Westinghouse Electric Company LLC
Hematite Decommissioning Project
3300 State Road P
Festus, MO 63028
USA

Direct tel: 314-810-3368
Direct fax: 636-937-6380
Email: hackmaek@westinghouse.com
Our ref: HEM-10-46
Date: May 24, 2010

Subject: Additional Information and Clarifications Concerning 10 CFR 20.2002 Alternate Waste Disposal Authorization and Exemption for Specific Hematite Decommissioning Project Waste (License No. SNM-00033, Docket No. 070-00036)

Additional Information and Clarifications Concerning 10 CFR 20.2002 Alternate Waste Disposal Authorization and Exemption for Hematite Decommissioning Project Waste

Figure 1
Radiation Levels on Rail Cars With Varying Soil Concentration
(at distances of 2 inches and 1 meter)

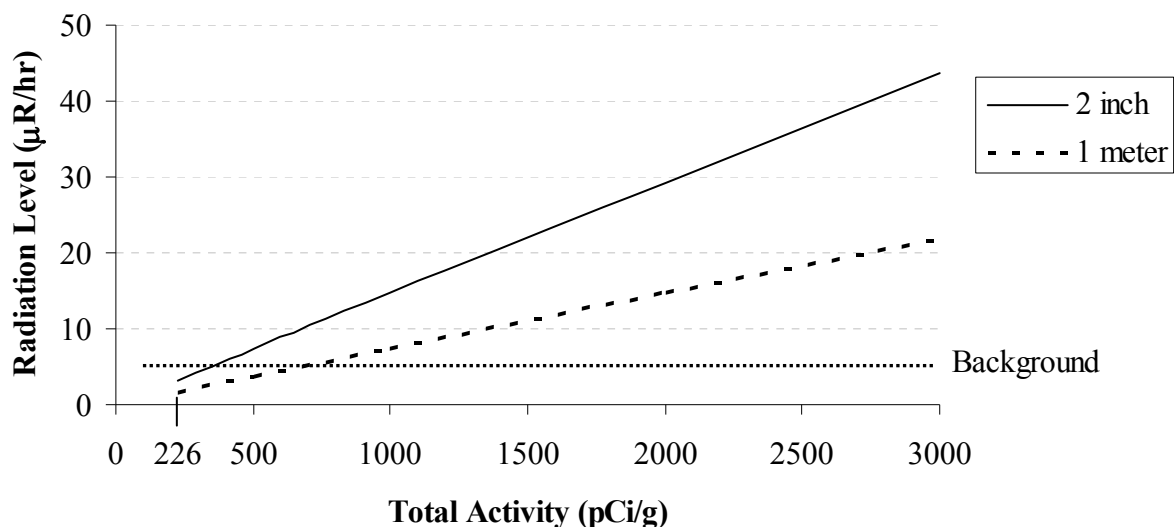
1. **NRC Question:** Provide information regarding the detection capabilities for radiological surveys and field measurements of soil during excavation and waste packaging for transportation.

Figure 1 illustrates the expected radiation levels on rail cars loaded with varying total activity concentrations in soil ranging from the expected median concentration value up to the USEI Waste Acceptance Criteria (WAC). As indicated in the figure, a significant departure from the expected median concentration (226 pCi/g) will be apparent through measurements of the radiation level. The radiation levels at a distance of two inches and at one meter for concentrations at the USEI waste acceptance criteria are 44 and 21 $\mu\text{R}/\text{hr}$, respectively.

The radiation levels in the figure above at a distance of 2 inches and at a distance of one meter were based on a MicroShield[®] model that assumed a soil density of 1.69 grams per cubic centimeter; a container wall thickness of $\frac{3}{8}$ inch; the expected median concentration in the first case; and the median concentration scaled to the USEI WAC in the second case.
